DESIGN ADVISORY BOARD Tuesday, August 22th, 2017 at 3:00 PM Conference Room 12, City Hall, Burlington, VT Agenda

1. 18-0059CA/CU; 308 Main St (RH, Ward 8E) 308 Main Street LLC

MEMORANDUM

To: The Design Advisory Board
From: Mary O'Neil, AICP, Principal Planner
RE: ZP18-0059CA/CU 308 Main Street
Date: August 22, 2017 Continued review

7 CARMICHAEL ST. ESSEX JUNCTION, VT 05452

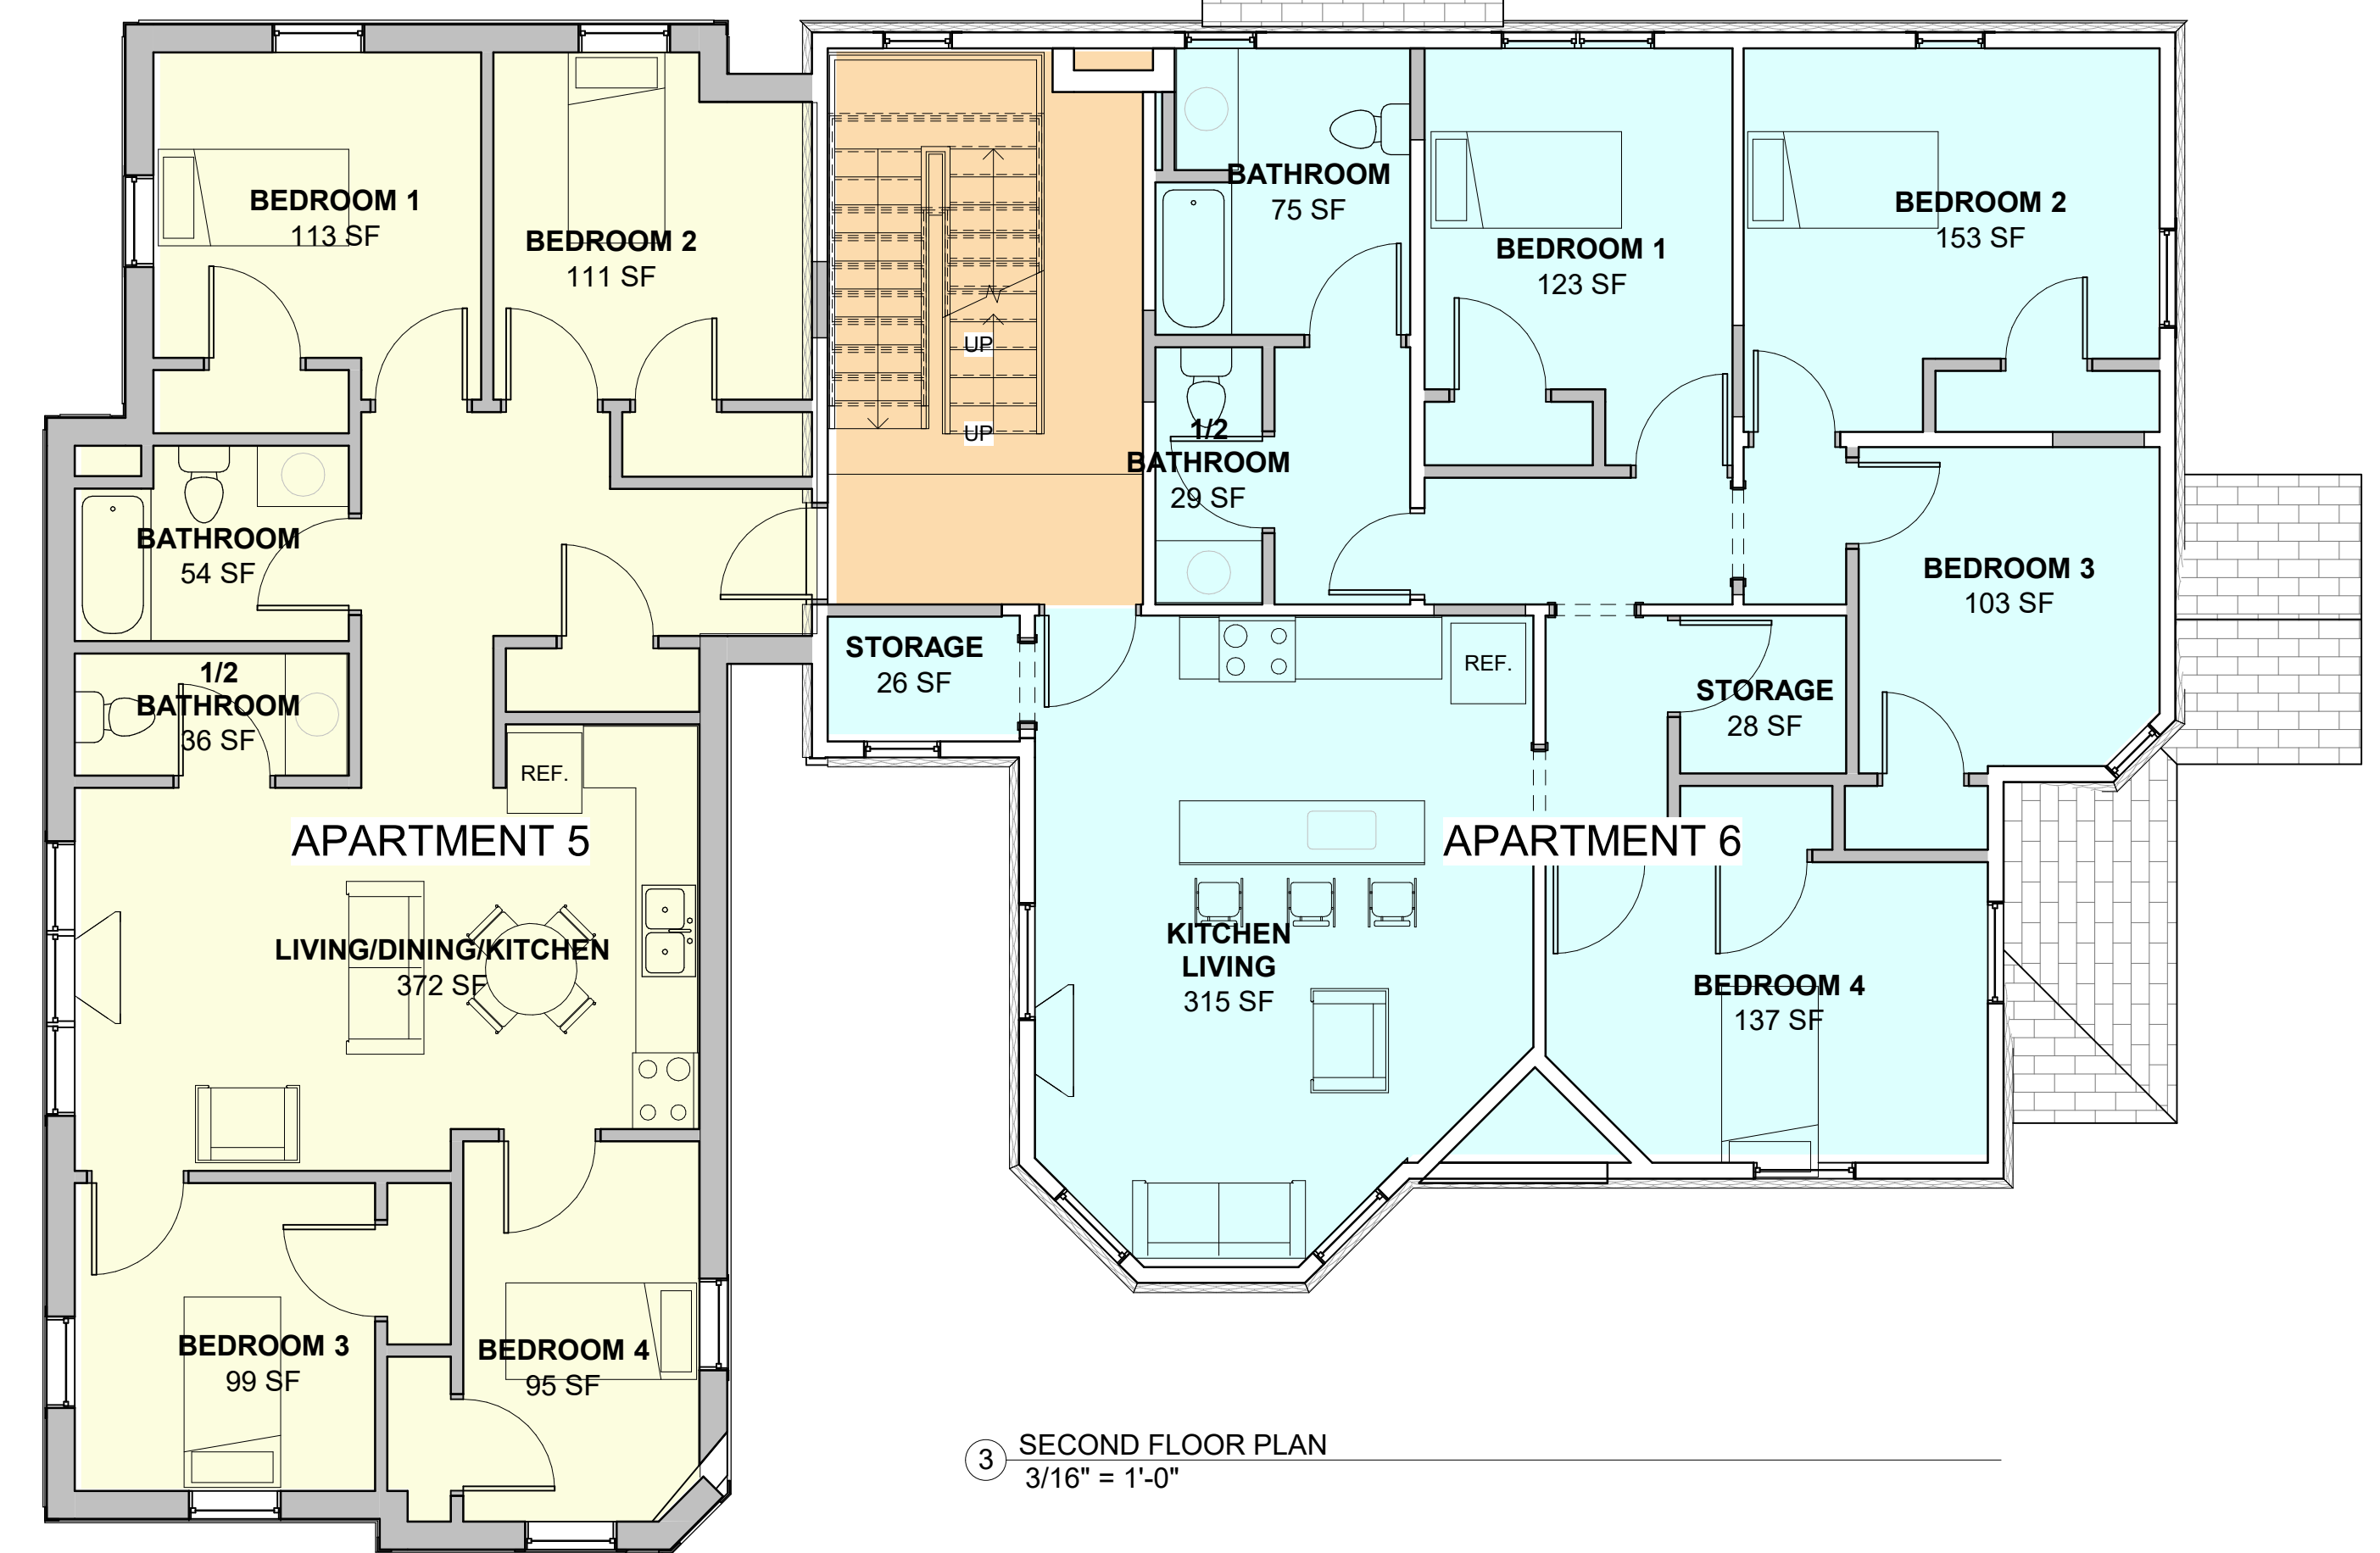
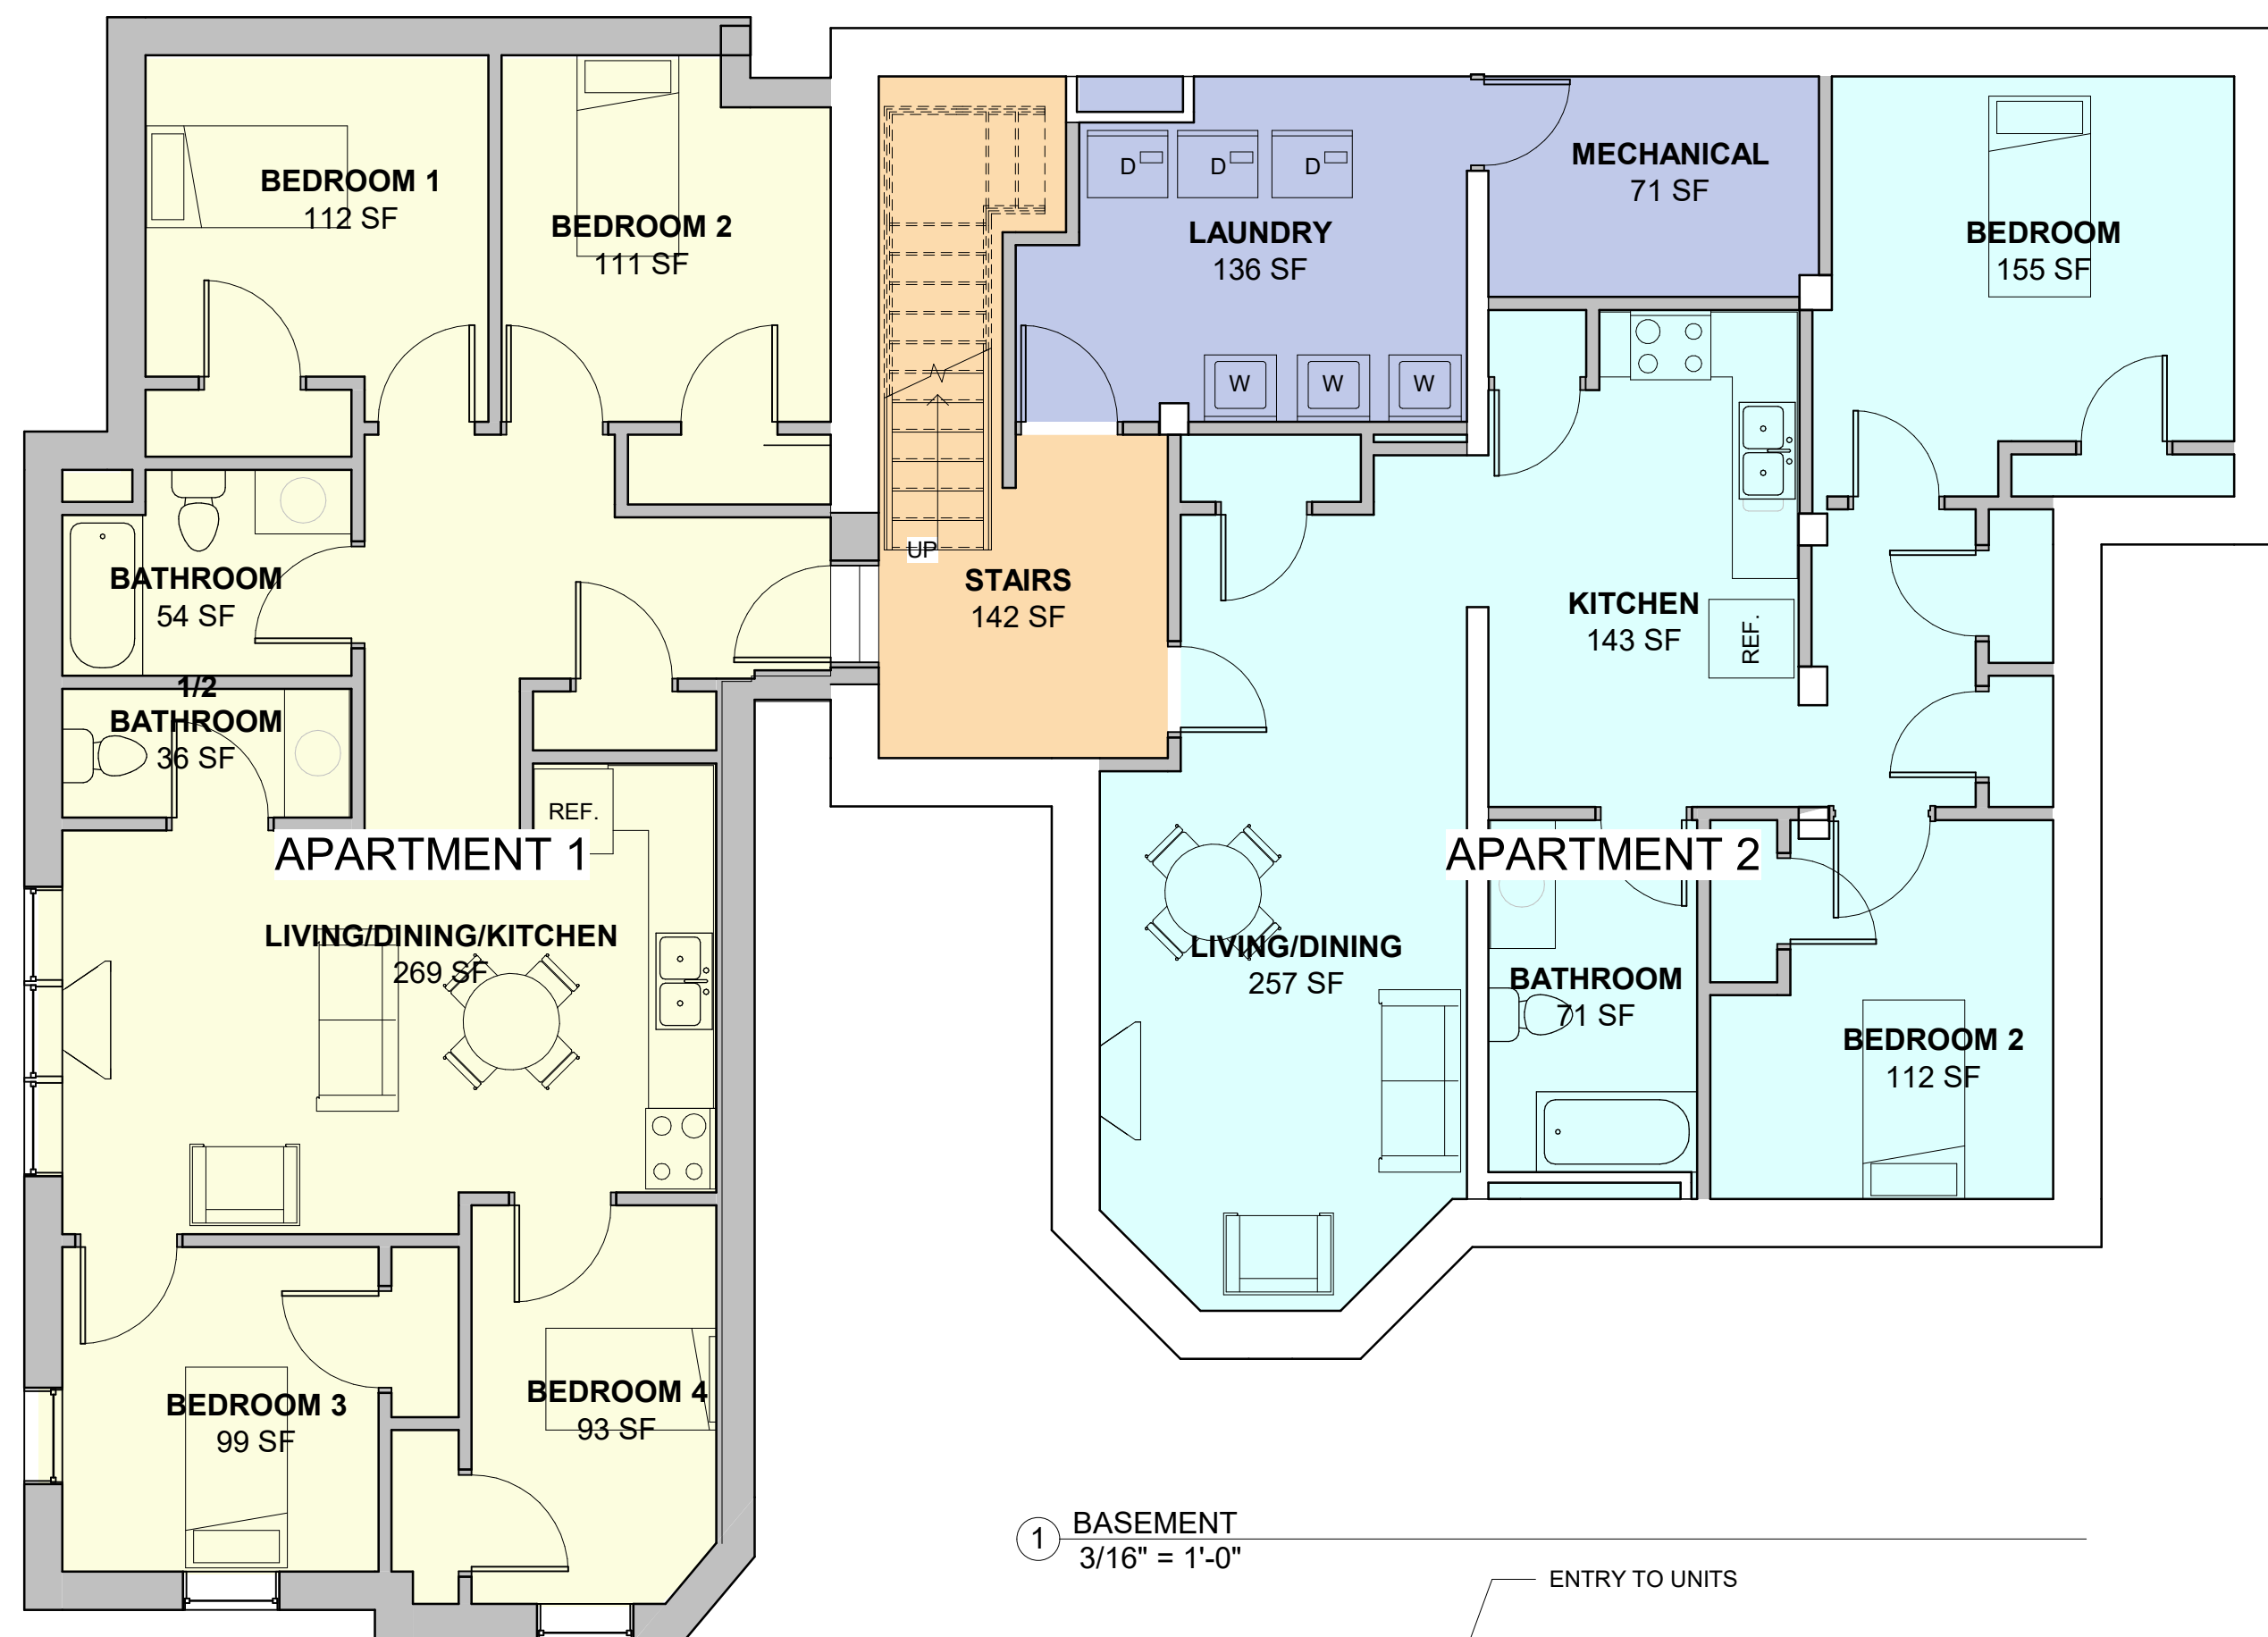
The proposal for a 3 ½ story flat roofed addition is quite contrary to the existing building and most within the streetscape. Submitted photos draw a parallel to the adjoining Captain Dan Lyons' house (1856); adjacent on the lot to the west. That structure precedes the Fisher House by more than a score of years. The principal structure has a low pitched hip roof with boxed cornice and broad projecting eaves, not a flat roof. It differs stylistically (early Italianate – and anecdotally originally had a roof lantern) and in massing (major structure with derivative rear ell); quite different from what is proposed at the back of 308 Main Street.

The scale proposed for the new addition is quite strident, given the sensitivity of the existing building and the proposed disparate architectural style. The addition is clearly visible from the streetscape (west, south and north) and generates conflict in proximity and appropriate scale to the Fisher House.

Although the applicant cites a neighboring building with a flat roof as support for this design, the addition bears no relationship to the existing historic structure. The sharp delineation of the roof form is quite contrary to the complex organization of the existing house; the differences abrupt and unsettling.

Direction given by the DAB's motion 8.8.2017 to create more pronounced articulation/ physical separation between the two masses, especially at the third floor roof line have spurred revised plans with a connector that slightly pushes the addition north, providing a pitched roof at the third floor between building masses.

The addition presents horizontal continuity of window bands. The windows themselves show no relationship to the existing building other than their arrangement so as to suggest floorlevels.

1. Applicant to make revision to reduce perceived scale relative to existing building by minimizing cornice at the top of the 3rd floor;
2. Eliminate panels to reduce verticality on east and west sides;
3. Material texture and color of 3rd floor be different;
4. Joint between building masses be different from primary cladding.
